## Product Change Notice (PCN)

**PCN Number:** PCN-080312\_01

Product(s) Affected: PJ-019

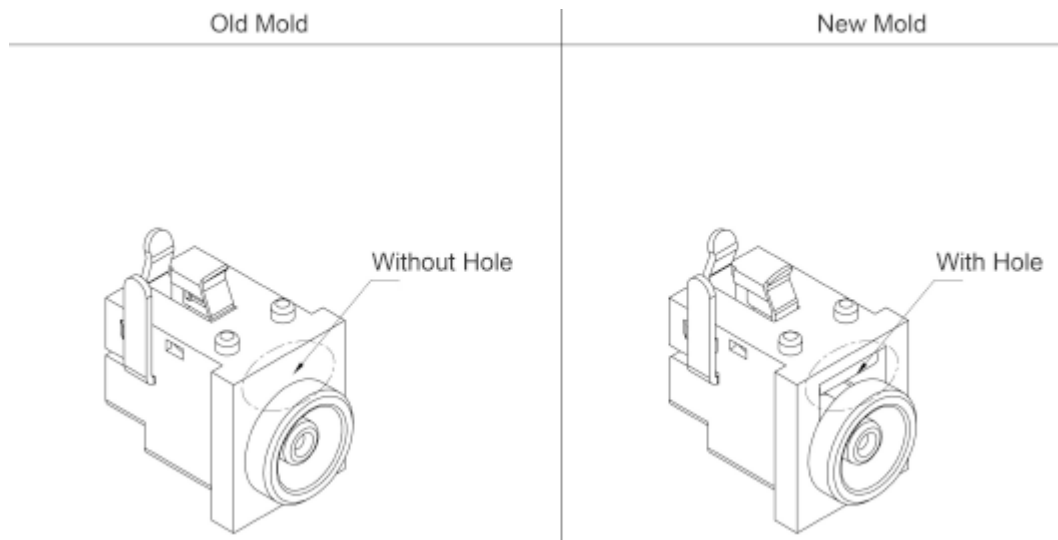
Reason(s) for Change: The mold for the plastic injection reach was discontinued.

Description of Change: There is now a small hole in the front of the jack.
